SERVICE BULLETIN

N° 189-282

ATA 32 – MAIN LANDING GEAR PINTLE PIN NEW BOLTS INSTALLATION

Figure 1

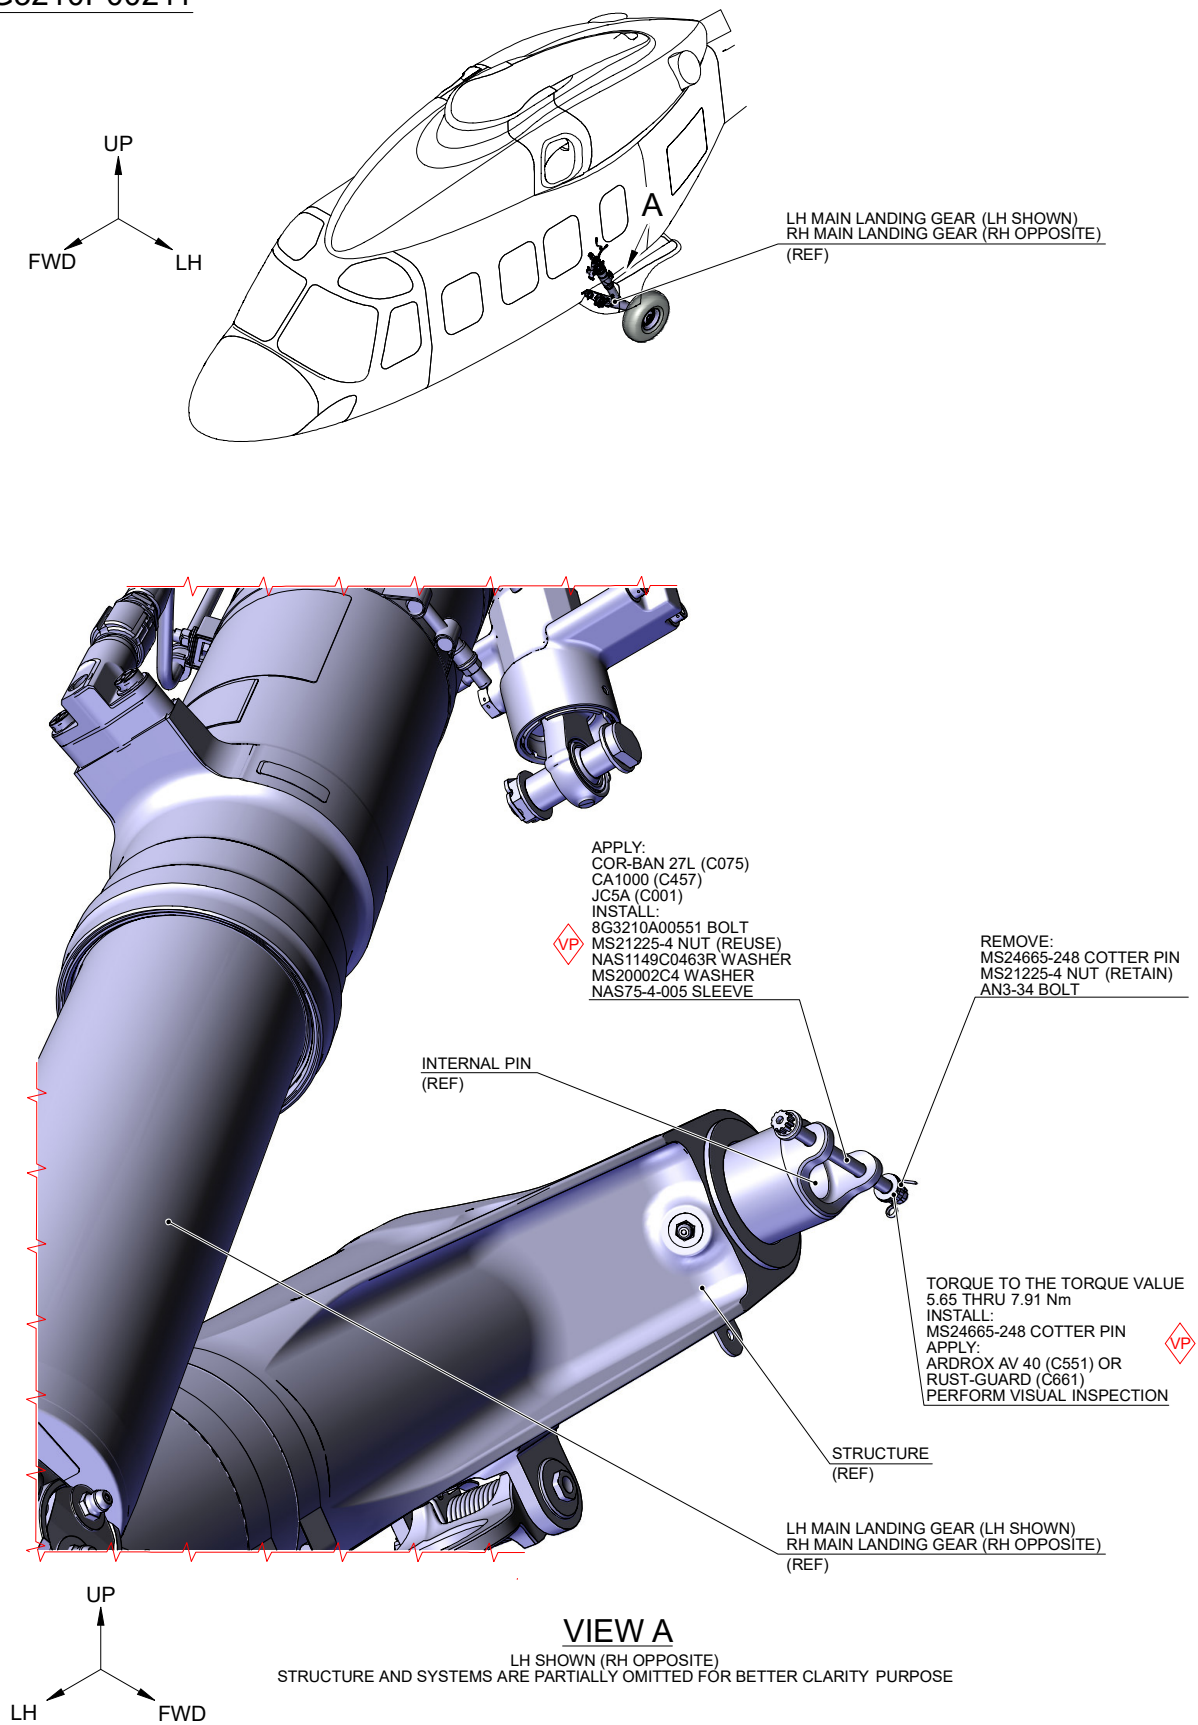
Leonardo Helicopters, after reports of excessive wear and damages to the safety bolt that secure the MLG internal pintle pins, developed a new design for this installation in order to prevent further occurrences.

This Service Bulletin provides the instruction to apply the "MLG bolt trailing arm retromod" P/N 8G3210P00211 in order to replace the safety bolt P/N AN3-34 of the pintle pin installation on MLG LH and RH with the new higher strength characteristics bolt P/N 8G3210A00551 and new related nut, washers and cotter pin.

- 2.1 With reference to Figure 1 view A and in accordance with the applicable steps of AMP DM 89-A-32-11-01-00A-520A-A, remove the cotter pin P/N MS24665-248, the nut P/N MS21225-4 and the bolt P/N AN3-34 from the LH MLG. Discard the bolt P/N AN3-34 and keep nut P/N MS21225-4 for further use.
- 2.2 With reference to Figure 1 view A and in accordance with AMP DM 89-A-32-11-01-00A-720A-A, perform the following procedure:
 - 2.2.1 With reference to Figure 1, apply the corrosion preventive compound Cor-ban 27L (C075) or the corrosion inhibitive compound CA1000 (C457) or the corrosion preventive compound JC5A (C001) under the head of the bolt P/N 8G3210A00551.

- 2.2.2 With reference to Figure 1 view A, install the bolt P/N 8G3210A00551, the sleeve P/N NAS75-4-005, the washer P/N MS20002C4, the washer P/N NAS1149C0463R and the existing nut P/N MS21225-4 that attach the internal pin to the structure.

- 2.2.3 With reference to Figure 1 view A, tighten the nut P/N MS21225-4 to 5.65 thru 7.91 Nm (50 thru 70 lbf in). Install the new cotter pin P/N MS24665-248.

- 2.3 With reference to Figure 1 view A and in accordance with the applicable steps of AMP DM 89-A-32-12-01-00A-520A-A, remove the cotter pin P/N MS24665-248, the nut P/N MS21225-4 and the bolt P/N AN3-34 from the RH MLG. Discard the bolt P/N AN3-34 and keep nut P/N MS21225-4 for further use

- 2.4 With reference to Figure 1 view A and in accordance with AMP DM 89-A-32-12-01-00A-720A-A, repeat Step 2.2 for the RH MLG.
3. Return the helicopter to flight configuration and record for compliance with this Service Bulletin on the helicopter logbook.
